# ENERGY STAR Qualified Homes Revision 04 Overview

# Revision 04 updates

Slab edge insulation detail for stucco wall systems

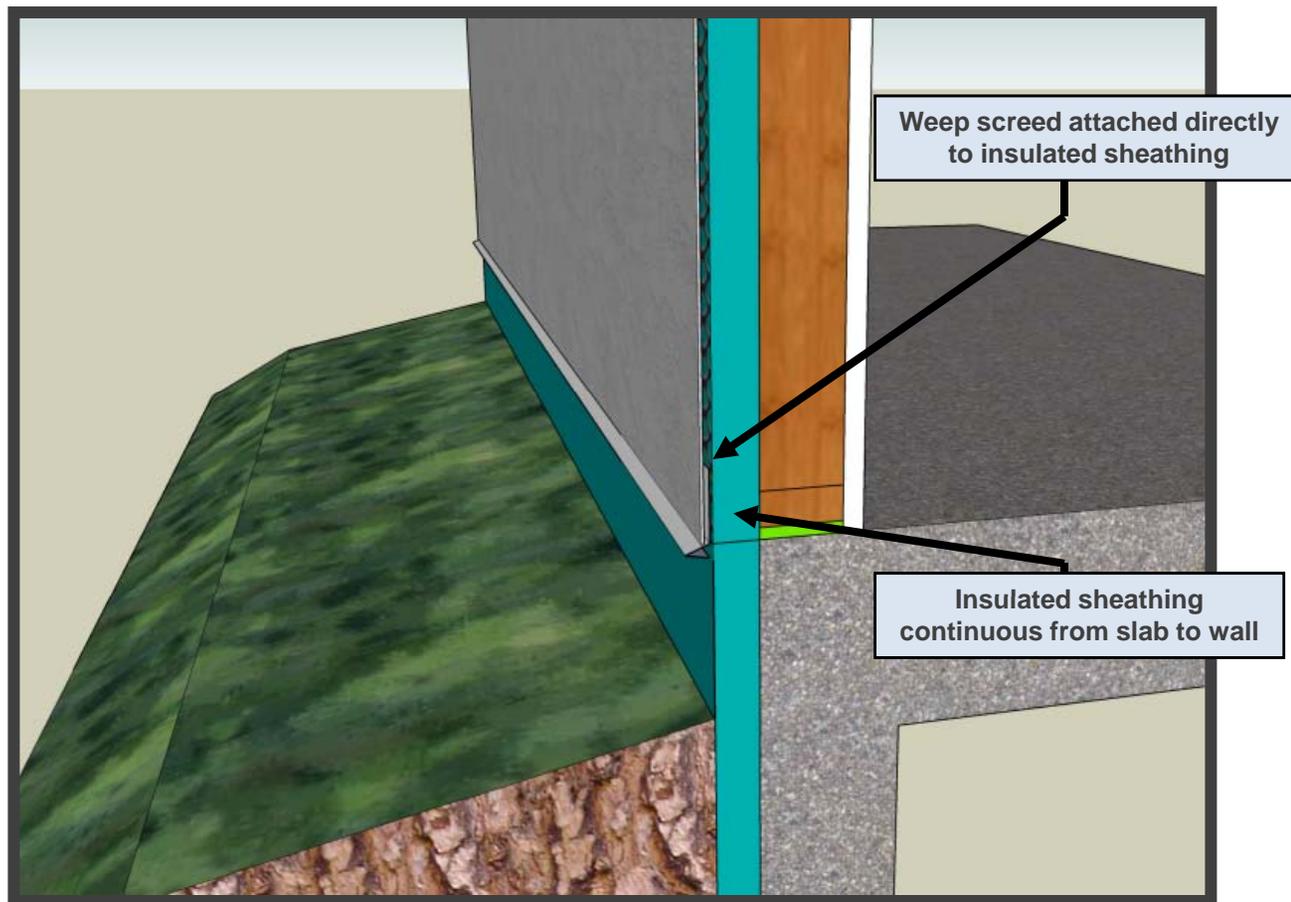
- **Thermal Enclosure System Rater Checklist**
  - Slab edge insulation detail for stucco wall systems
    - Walls can be designed such that the weep screed rests upon slab insulation rather than directly on the foundation. For example, the sheathing of the exterior wall can be aligned in the same plane as the foundation insulation, providing a continuous insulated surface. Therefore, insulation must extend behind the weep screed to satisfy the intent of Item 4.2.

Slab edge insulation exemption for post-tensioned slabs

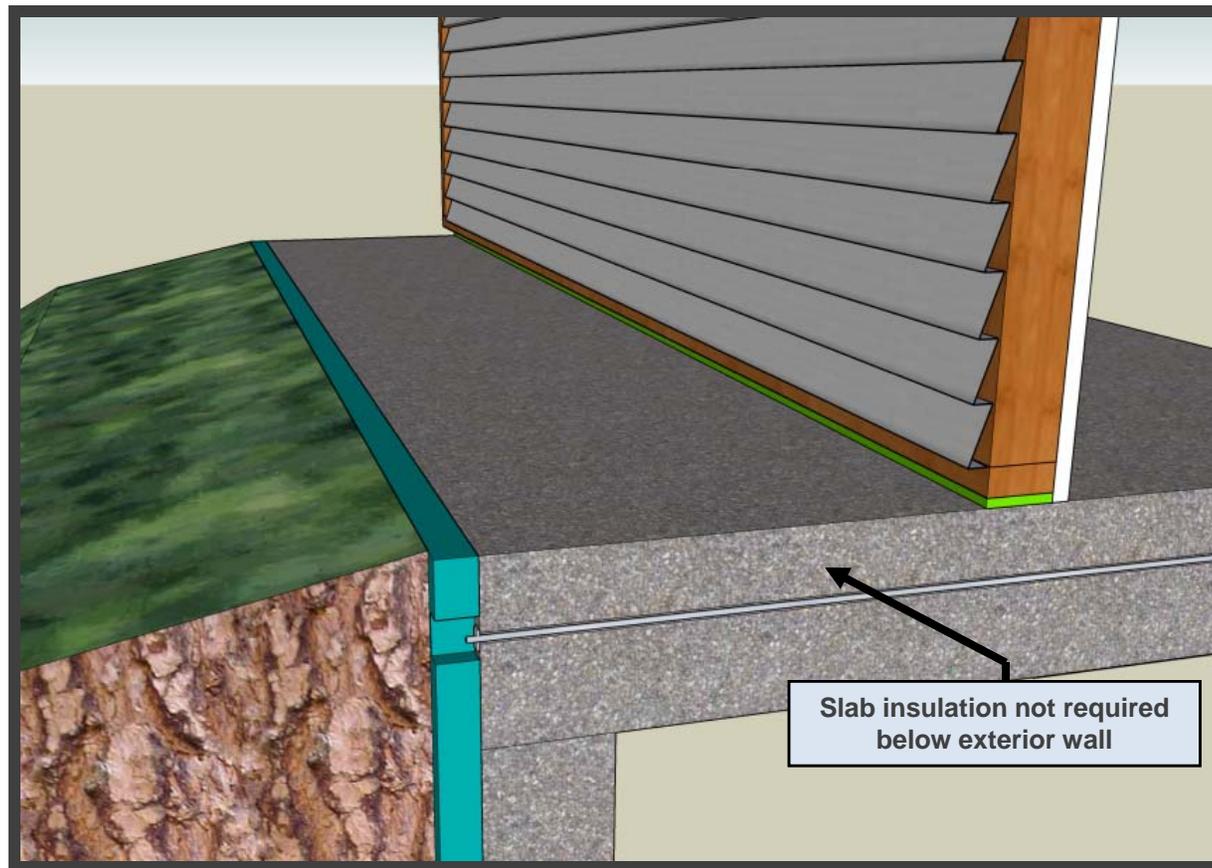
- **Thermal Enclosure System Rater Checklist**
  - Slab edge insulation exemption for post-tensioned slabs
    - Where a continuous post-tensioned slab extends from conditioned to unconditioned space (e.g., from conditioned space to an adjacent unconditioned hallway, to an unconditioned garage, to a porch), insulation is not required to be provided at this boundary to satisfy Item 4.2. This exemption applies to both multifamily and single-family homes.

Slab edge insulation detail for monolithic slabs with brick ledges

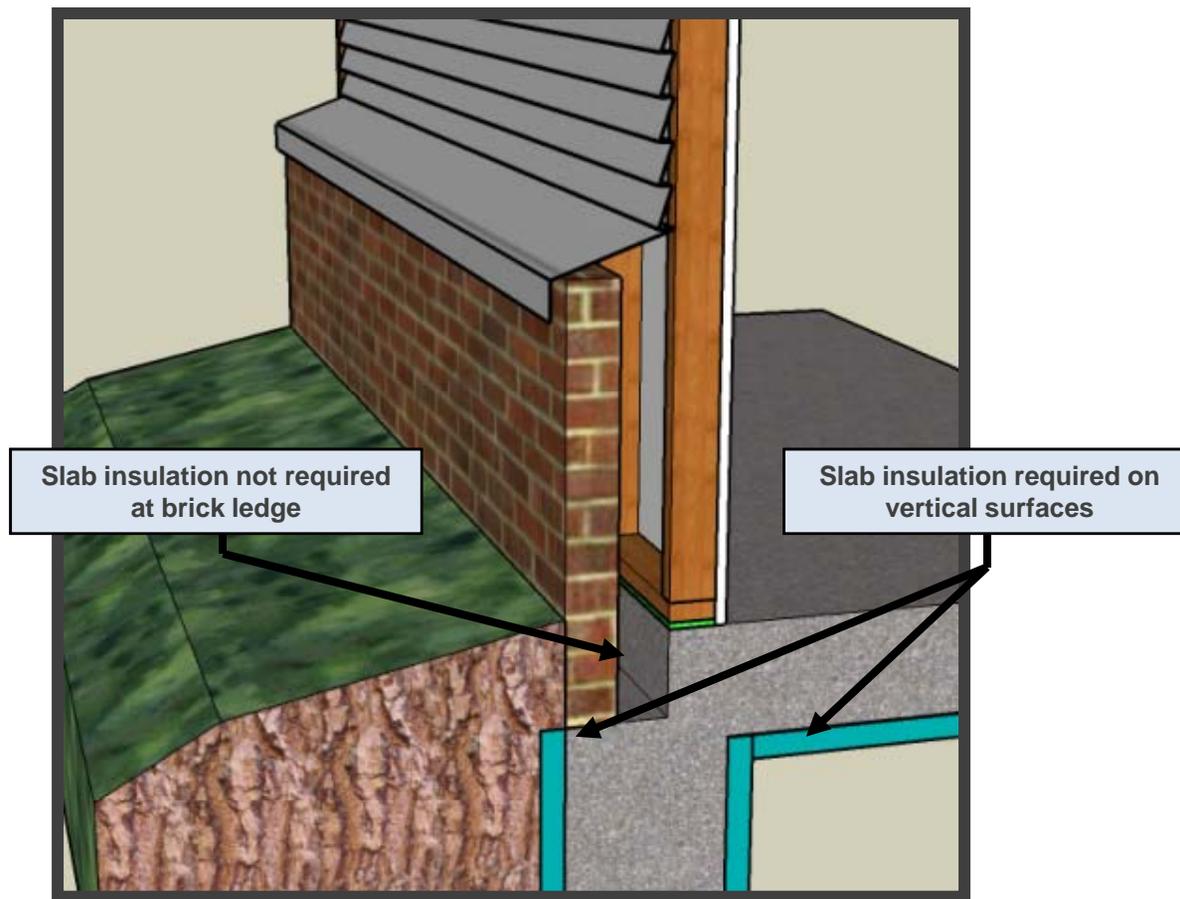
- **Thermal Enclosure System Rater Checklist**
  - Slab edge insulation detail for monolithic slabs with brick ledges
    - EPA will not require the horizontal brick ledge of monolithic slabs to be insulated in order to satisfy the intent of Item 4.2. However, the vertical surface on either side of the ledge shall be insulated. Furthermore, floating slabs with brick ledges are not exempted because the insulation layer can be moved to the interior vertical surface of the foundation.

Slab edge insulation exemption for termite view strips

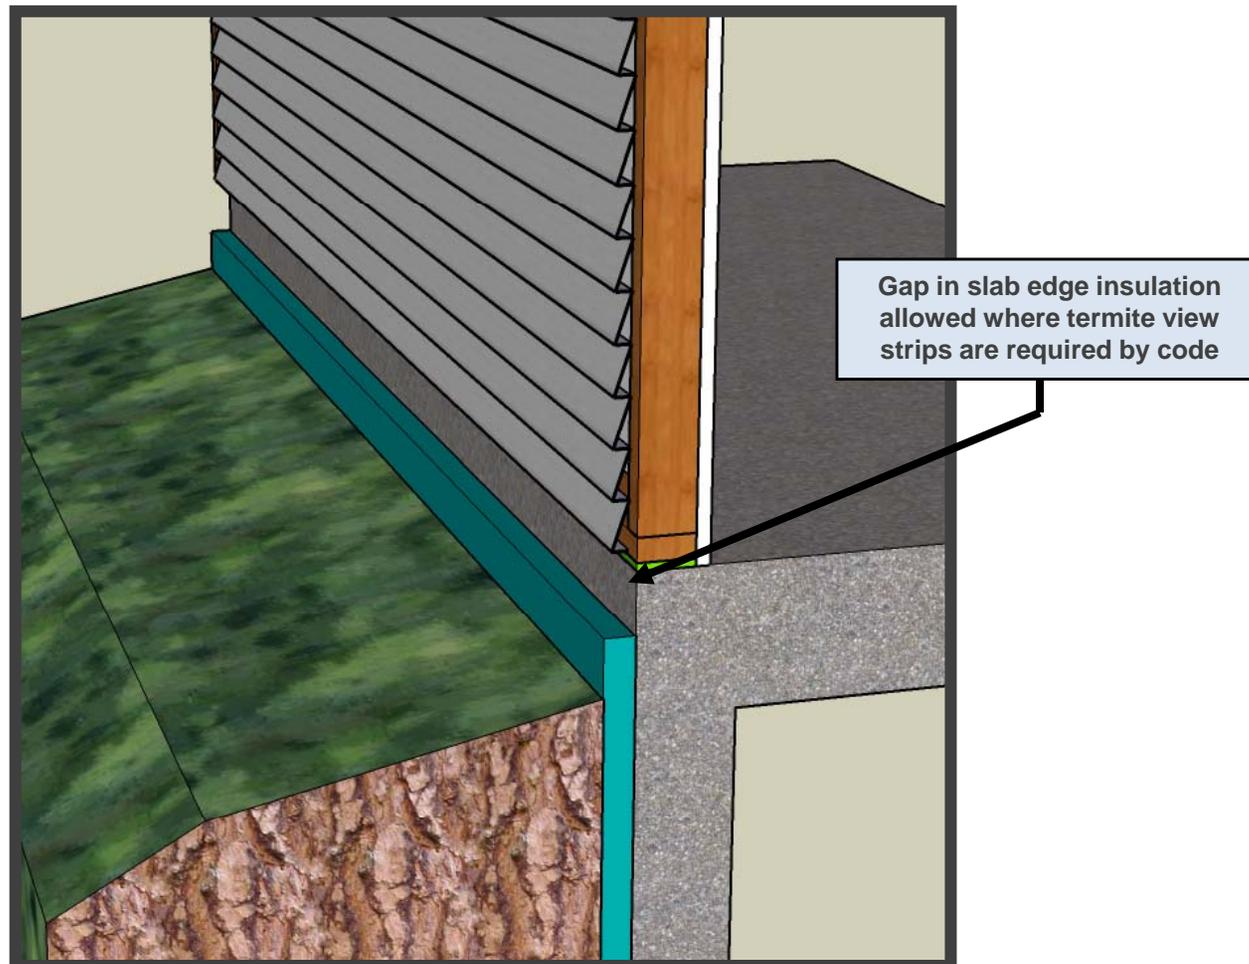
- Slab edge insulation exemption for termite view strips
  - Homes that have uninsulated termite view strips due to code requirements satisfy the intent of Item 4.2.
  - As noted in the footnotes of the National Program Requirements (Rev. 04), “In cases where overlapping requirements conflict with a requirement of these ENERGY STAR guidelines (e.g., slab insulation is prohibited to allow visual access for termite inspections), then the conflicting requirement within these guidelines shall not be met. Qualification shall only be allowed if the rater has determined that no equivalent option is available that could meet the intent of the conflicting requirement of these ENERGY STAR guidelines (e.g., switching from exterior to interior slab edge insulation).”
